2022/4114 - 46 Blythwood Road Hornsey London N4 4EX

Approval of details reserved by conditions 3 (materials), 4 (cycle parking), 5 (refuse) and 8 (hydrological and hydro-geological impact assessment) of HGY/2021/2612.

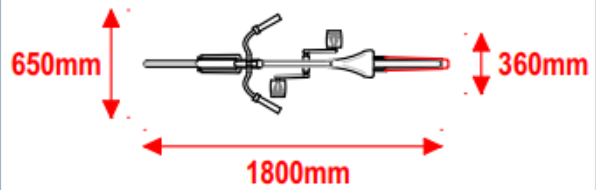
The external cycle parking is shown within a store, which is dimensioned at 1700mm width at the point three cycles are stored. There’s no detail of how the cycles will be fixed within the store, whether this is to Sheffield Stands, or an alternative fixing system. 1700mm would not be sufficiently wide to accommodate 3 cycles next to each other as shown on the drawing (see below) as a single cycle requires 650mm.

If the cycles are to be fixed to Sheffield Stands, it would be possible to accommodate 3 cycles within the store as dimensioned.

There are no details as to whether the cycle store is timber, or steel, nor any details of the security/locking mechanism to ensure sufficient security.

The original application made reference to the provision of a charging facility for electric cycles, this does not appear to be shown or detailed.

Finally, the submitted drawing references a 'wheeling channel if required'. The condition requires details of the wheeling channels to be installed, such as the material, width etc.

The applicant needs to provide the information referenced in this response, and to resubmit their details to discharge the requirements of condition 4.
